HARMONY RIDGE SUBDIVISION

UNIT FOUR

APPLICATION NUMBER 30 DATE January 3, 2008

DETAIL SITE PLAN

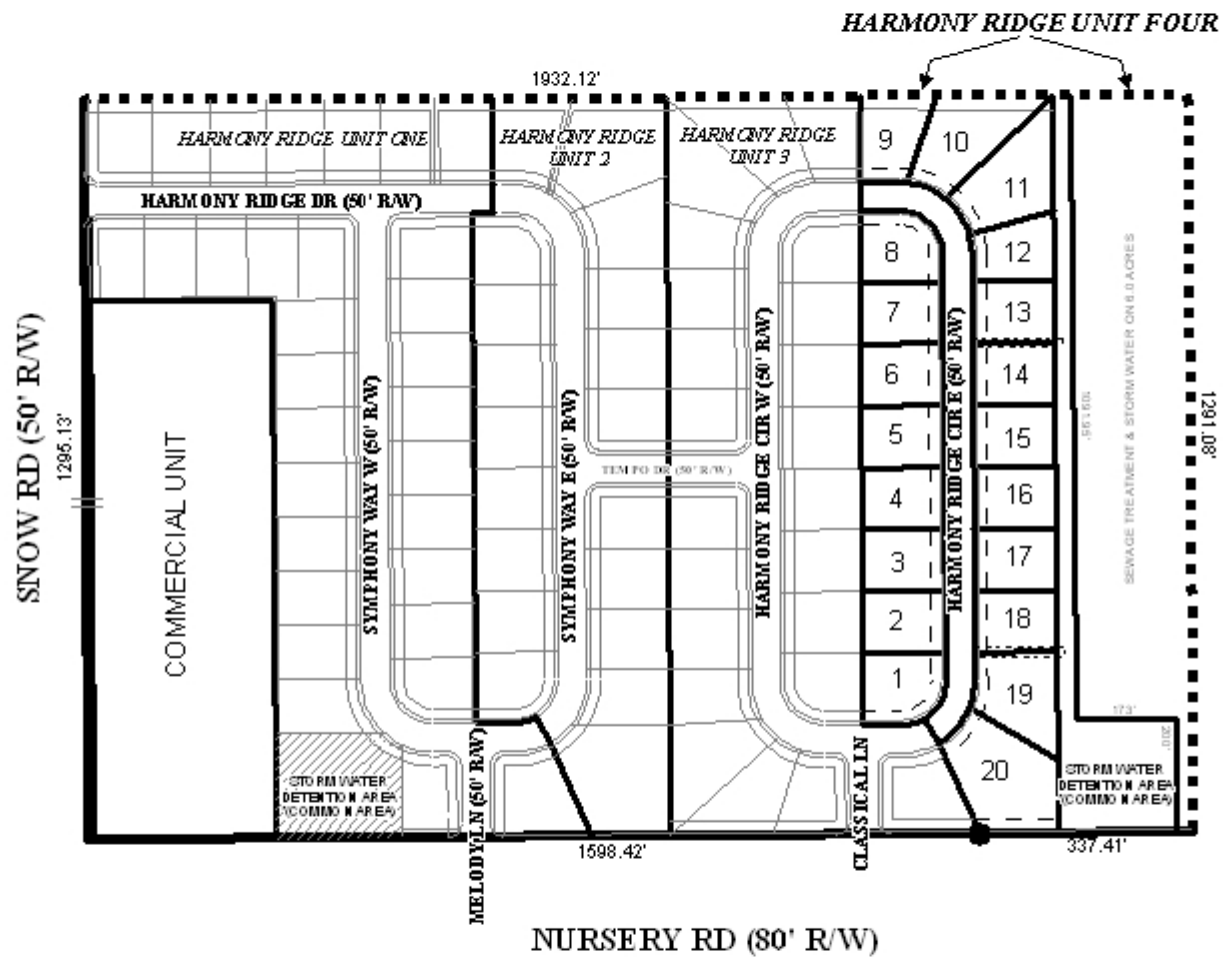
The plat illustrates the final unit of Harmony Subdivision, which fronts Nursery Road, a minor street with sufficient right-of-way. All lots within the subdivision have adequate street frontage on Harmony Ridge Circle East, a proposed street with sufficient right-of-way. A note should be placed on the final plat stating that each lot is limited to one curb cut to Harmony Ridge Circle East. Another note should be placed on the final plat stating that Lot 20 is denied direct access to Nursery Road.

As illustrated on the plat, a common area is proposed on the Eastern part of the subdivision. A note should be placed on the final plat stating that maintenance of all common areas is the responsibility of the property owners of Harmony Subdivision.

As stated above, the subdivision will be served by public water and sanitary sewer. However, the sewer system will be a centralized effluent disposal system. With this type of system, each lot will have an individual septic tank. While all lots appear to meet the minimum size requirement for developments with access to public water and individual septic tanks, it is requested that the applicant revise the plat to label the lots with their sizes in square feet, or provide a table on the plat with the same information.

The site is located in the county; therefore, a note should be placed on the final plat stating that any lots developed commercially and adjoin residentially developed property shall provide a buffer in compliance with Section V.A.7. of the Subdivision Regulations.

- 1) placement of a note stating that all lots will be limited to one curb cut to Harmony Ridge Circle East;
- 2) placement of note stating that Lot 20 is denied direct access to Nursery Road;

- 3) placement of a note stating that maintenance of all common areas is the responsibility of the property owners of Harmony Subdivision;
- 4) labeling of the lots with their sizes in square feet, or provide a table on the plat with the same information;

- 5) placement of a note on the final plat stating that any lots developed commercially and adjoin residentially developed property shall provide a buffer in compliance with Section V.A.7. of the Subdivision Regulations; and
